CHAPTER 3

Comments and Responses

3.1 Comments on the Draft EIR and Responses

This section contains all comment letters and responses to comments. Each comment letter is assigned an alphanumeric code, from A1 through C40, and each comment is numbered in the margin of the comment letter. Responses to the comments follow each letter, and responses are referenced using the same alphanumeric system. For example, the first comment from the first letter, from the National Oceanic and Atmospheric Administration, is designated A1-1, as is the response to it. Testimony from the public hearing is assigned the code “PH” and follows the comment letters.

Figure 3-3
Ross Valley Flood Protection and Watershed Program

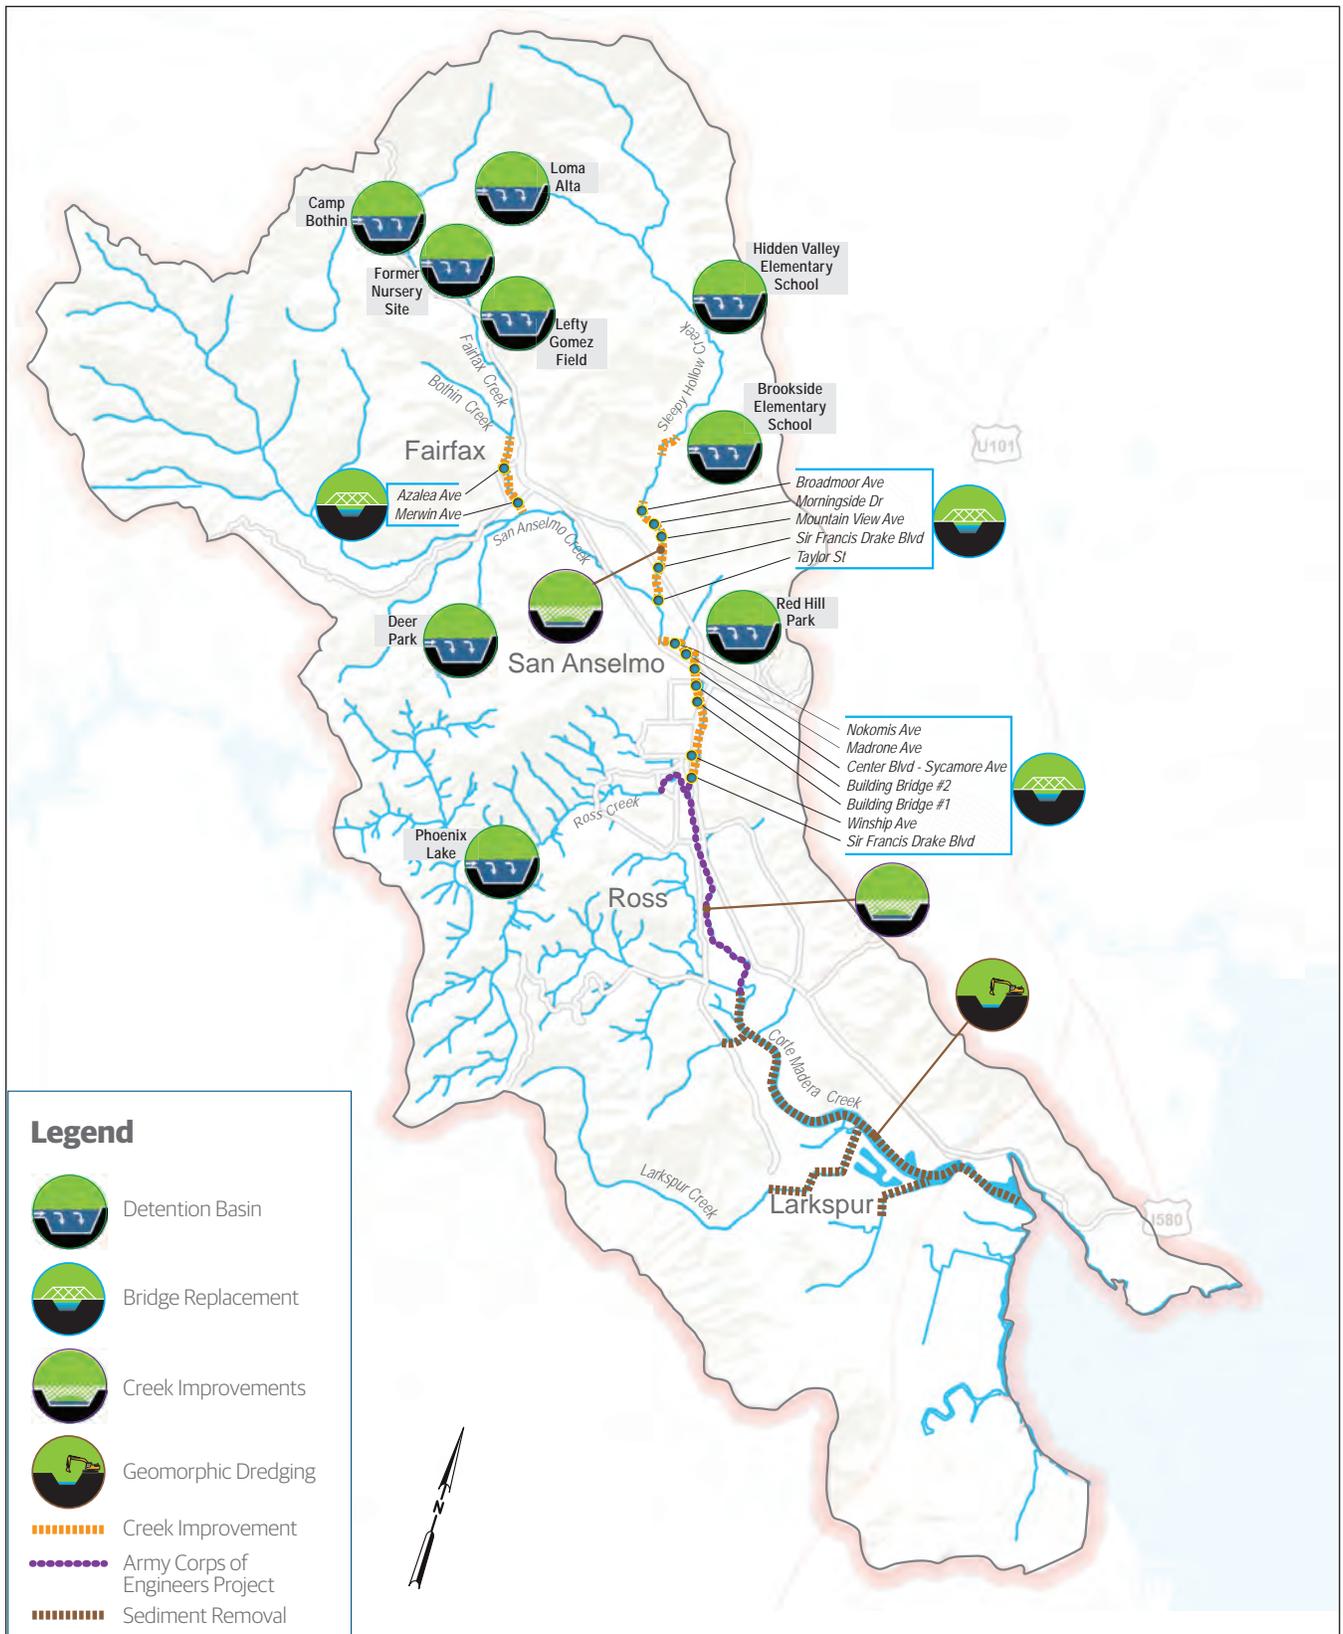
- C4-1 This comment says that the map illustrating elements of the Ross Valley Flood Protection and Watershed Program (Figure 3-3) and text describing some of those elements should be revised to exclude Memorial Park, Lefty Gomez, Deer Park, and all other sites on land designated for education.

These comments relate to the Ross Valley Program currently under development. Few specific decisions have been made as to what elements would eventually be constructed as part of the Ross Valley Program. As suggested in this comment, an updated map of the Ross Valley Program has been inserted in place of the previous version of Figure 3-3 in the Final EIR. The revisions to this figure do not result in any changes to the environmental analysis included in the Draft EIR.

In response to Comment C4-1, Draft EIR Figure 3-3 (page 3-5) has been revised, as shown on the following page.
